### TRUCK SUSPENSION

No: 97117-206  
Subject: PRIMAAX EX - GEN II HYBRID  
Date: NOVEMBER – 2009 Revision: A

**Figure One**  
**Primaax Gen II and Primaax EX**  
**Main Support Beam Configuration**

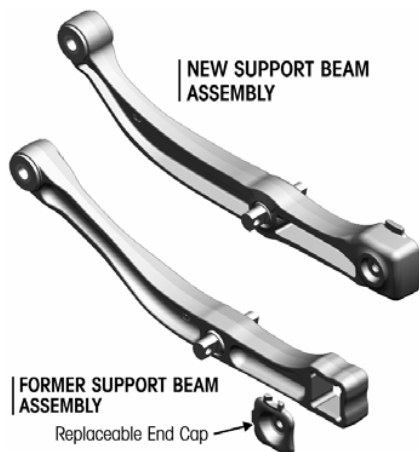
1. Hendrickson Asia Pacific (HAPPL) and Iveco Trucks Australia Limited (ITAL) in partnership have completed exhaustive testing of the new improved Primaax EX suspension. The testing was modeled to suite our unique Australian conditions thereby ensuring that the suspension is capable of meeting severe duty conditions. The new design provides greater durability in approved applications with the ride quality and stability remaining consistent with the original design.
2. The most obvious changes between the earlier Generation II Primaax and Primaax EX is the integration of the cast end cap, as shown at Figure 1.
